Planning Commission Staff Report

HAMPTON INN MIXED USE PROJECT

Conditional Use, Planned Development
and Conditional Building and Site Design Review
PLNPCM2010-00236, PLNSUB2009-00383
1345 & 1355 South Foothill Drive
Hearing date: June 9, 2010

DEVELOPMENT PLAN
1" = 20'-0"

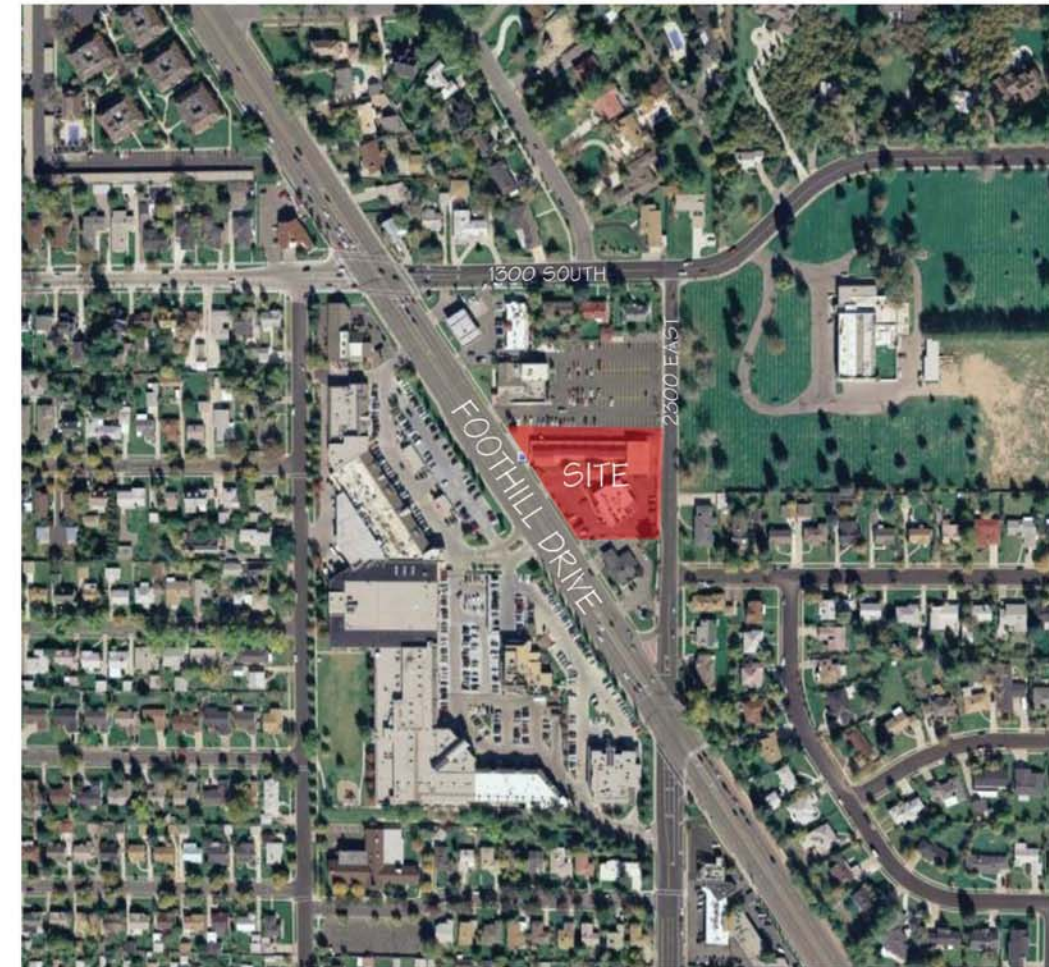
- **Parking setback (21A.26.030.F.7):** The project includes a two level parking structure which has a setback requirement of 35 feet from a front property line in the CB district. With the two front property lines (Foothill Drive and 2300 East), available area for any type of parking structure is extremely limited and would not be cost effective. The proposed parking structure is located and designed as to be hidden from view from Foothill Drive. This is achieved by locating the lower level parking area behind the dental office building, and the upper level parking area above the same building but with a screen wall to prevent view of vehicles. When viewed from 2300 East, the upper level parking area is at the same level as the public street and would appear as a surface level parking area with a screen wall to limit view of the vehicles. The parking structure complies with the setback from the property line along Foothill Drive, but would be located approximately three feet from the property line along 2300 East. The applicant seeks approval for this reduced setback through the *planned development* review process.

In this case, the number of proposed parking stalls exceeds the number that would typically be required for the project by approximately 24 stalls. The number of hotel rooms would require 41 stalls (1 stall per every 2 rooms); retail area would require 4 stalls (2 stalls per 1,000 sq ft); dental offices would require 12 stalls (5 stalls per 1,000 sq ft) – for a total of 57 stalls. The applicant proposes 81 stalls. Removal of 24 stalls from the eastern area of the parking structure would provide opportunity for a greater setback, although not likely the full 35 feet. However, pulling the parking structure further into the interior of the lot would create a more abrupt view of both parking levels from 2300 East, thereby leaving little question that a parking structure exists on the site. Compare that to the proposed design which prevents a view of the lower level parking area from 2300 East, thereby giving less sense of an imposing parking structure. The proposed design also works well with the significant grade change as it drops toward Foothill Drive.

- **Dumpster located in a front yard (21A.36.020.B):** Dumpsters are only allowed in a rear yard. In this situation, with two front yards and no rear yard, some relief would be required to place a dumpster on the site. The proposed location on the second level in the southeast corner of the parking structure, it is within the front yard along 2300 East. The dumpster will be screened and kept in a fenced in area that will be accessible for pick up by trash trucks from 2300 East. Again, the applicant seeks approval for this location through the *planned development* review process. Staff supports relief of this requirement due to the lot having double frontage and with the proposed screening.

- **Transportation (Barry Walsh):** Provide pedestrian access from public sidewalk to building entry. Provide parking structure grid dimensions for proper column spacing and parking stall buffer compliance. Provide required 5% required bicycle parking with details and locations. A 4% maximum slide slope for parking stalls exposed to snow and ice. Ramp to upper level parking and the entry to the parking level need to match grade percentages.

5. Allowed modifications from standards:
 1. *Building height up to 35 feet*
 2. *Parking structure setback reduced to three feet from 2300 east property line.*

3. *Dumpster can be located where shown, on second level of parking structure within what would normally be considered the front yard adjacent to 2300 E.*

WEST ELEVATION

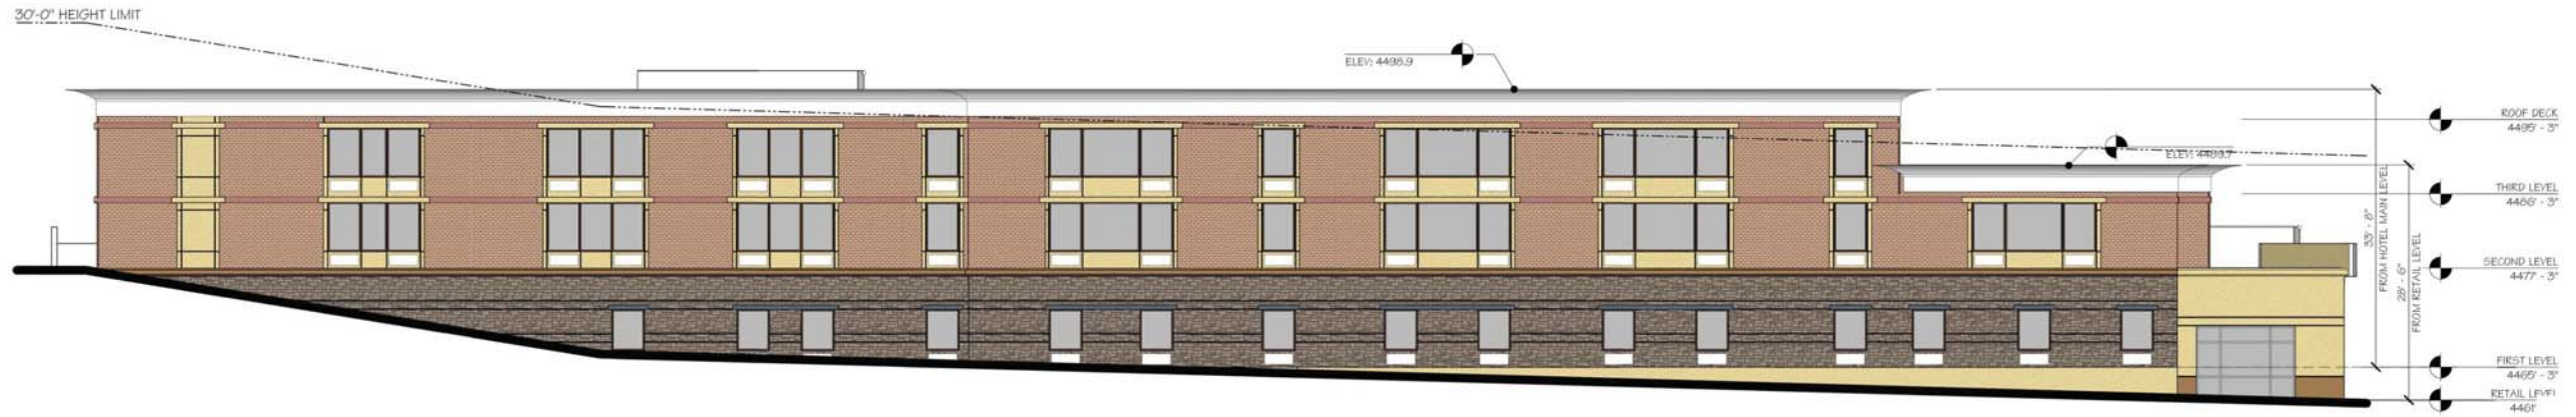
- Building height in the CB district (*21A.26.030.H*): The CB district limits the building height to 30 feet. The proposed hotel building complies with this limit for most sections of the building but there is one portion of the building where the building height reaches close to 35 feet. That section begins 55 feet from the front façade of the building along Foothill Drive and is approximately the middle 1/3 of the building along the east/west axis. When viewed from Foothill Drive, the building is stepped back at the 2nd and 3rd stories, lessening the visual impact of the overall building height; however, the sloping lot makes it difficult to stay under 30 feet at all portions of the building. The Zoning Ordinance section *21A.26.010.J* permits the planning commission, by conditional use, to allow additional building height if the first floor of the building exceeds 20,000 square feet, which the proposed building does (approx 22,000 sq ft). The planned development process also allows for an additional five feet in building height when approved by the planning commission.

The significant change in grade on this lot causes difficulty for commercial buildings in relation to a 30-foot building height limit. The proposed building has been revised to include stepped back facades as it increases in height as viewed from the front (Foothill Drive). This tactic reduces the visual impact and adds architectural interest to the building. Staff supports the proposed building height and design to reduce visual impact.

- Minimum first floor glass (*21A.26.030.I*): The building facade facing Foothill Drive is required to have a minimum of forty percent (40%) non-reflective glass. The proposal satisfies this requirement. In addition, and due to the double frontage lot, the building façade along 2300 East

is subject to the same requirement. Given that the building contains hotel rooms, the applicant seeks relief from the glass requirement along 2300 East to avoid making the hotel rooms easily viewable by the passing public. Each hotel room facing 2300 East will have transparent glass windows with curtains on the inside but the total glass content will not reach 40 percent, instead a 25% content is proposed. Adding more glass and more curtains would not be in line with the intent of the glass requirement to increase pedestrian interest in the use. Relief from this requirement can be granted by the planning commission through the *conditional building and site design review* process (associated standards are discussed later in this report).

Staff recognizes the hardship created by a double frontage lot and the irony of creating more visual interest in hotel rooms along 2300 East. Staff supports relief of the glass requirement along 2300 East.

4. *No public pedestrian entrance required for façade facing 2300 E.*
 5. *Reduction from 40% to 25% for required glass content along 2300 E.*
 6. *No additional canopy trees within the parking areas as required for each six parking spaces.*
